Access Compliance Report Public Rights-of-Way (Curb Ramps)

Main Street: RED_HILL_AVE Cross Street: RAINBOW_DR Location: SE

ADA ID: RPAT211021141203 Ramp Type: Type 1 - Perpendicular Diagonal Initial Pass/Fail: Pass Overall Compliance: No Severity Score: 14

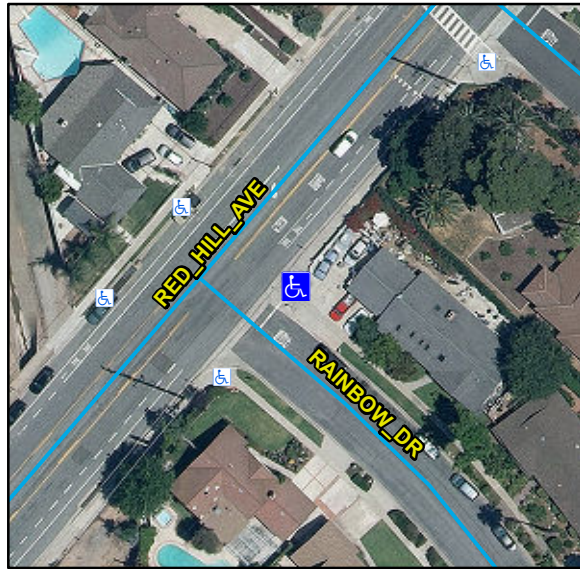
R304.2.2, R204.3, R304.2.1, R304.2.2-Perp, R304.3.2-Para, R305, STD 1115

Compliance	Description	Data	Compliance	Description	Data
N/A	Ramp Length (in)	80	N/A	Flare Type LT	
Yes	Ramp Width (in)	60			Sloped
Yes	Ramp Run Slope (%)	6.9	N/A	Flare Slope LT (%)	4.9
Yes	Ramp Cross Slope (%)	1.1	N/A	Flare Traversable LT	No
N/A	Landing Present	Yes	N/A	Flare Type RT	
N/A	Landing Length (in)	40			Sloped
Yes	Landing Width (in)	60	N/A	Flare Slope RT (%)	6.9
No	Landing Run Slope (%)	2.8	N/A	Flare Traversable RT	No
Yes	Landing Cross Slope (%)	0.2	No	DWS Provided	No
N/A	Landing Movement Obstructed?	Yes	N/A	DWS Contrast	N/A
	Landing Movement Type	wall	N/A	DWS Length (in)	N/A
N/A	Landing Shared	No	N/A	DWS Full Width	N/A
N/A	Clear Space	Yes	N/A	DWS Offset Left (in)	N/A
N/A	Clear Space To Crosswalk (in)	48	N/A	DWS Offset Right (in)	N/A
N/A	Marked Crosswalk 1	No	N/A	Marked Crosswalk 2	No
	Crossing 1 Direction	NW		Crossing 2 Direction	SW
	Marked Crosswalk 1 Width (in)	N/A		Marked Crosswalk 2 Width (in)	N/A

N/A	Ramp Inside Crosswalk 1	N/A	Yes	Ramp Inside Crosswalk 2	N/A
	Crossing 1 Slope (%)	4.4		Crossing 2 Slope (%)	3.1
	Crossing 1 Cross Slope (%)	0.8		Crossing 2 Cross Slope (%)	1.5
Yes	Gutter Ponding	No	No	Curb Slope	6.6
Yes	Gutter Lip Height (in)	0		Road Run Slope (%)	1.3
Yes	Gutter Run Slope (%)	2.9		Road Cross Slope (%)	2.5
Yes	Gutter Cross Slope (%)	1.2			
Yes	Overall Surface Condition: Acceptable		No	Perp Joint Present	No
	Cross Gutter Present?	Yes		Spandrel Present?	Yes
	Replace Cross Gutter?	No		Replace Spandrel?	No

Remove & Replace Curb Ramp With Two New Directional Ramps or Equivalent.
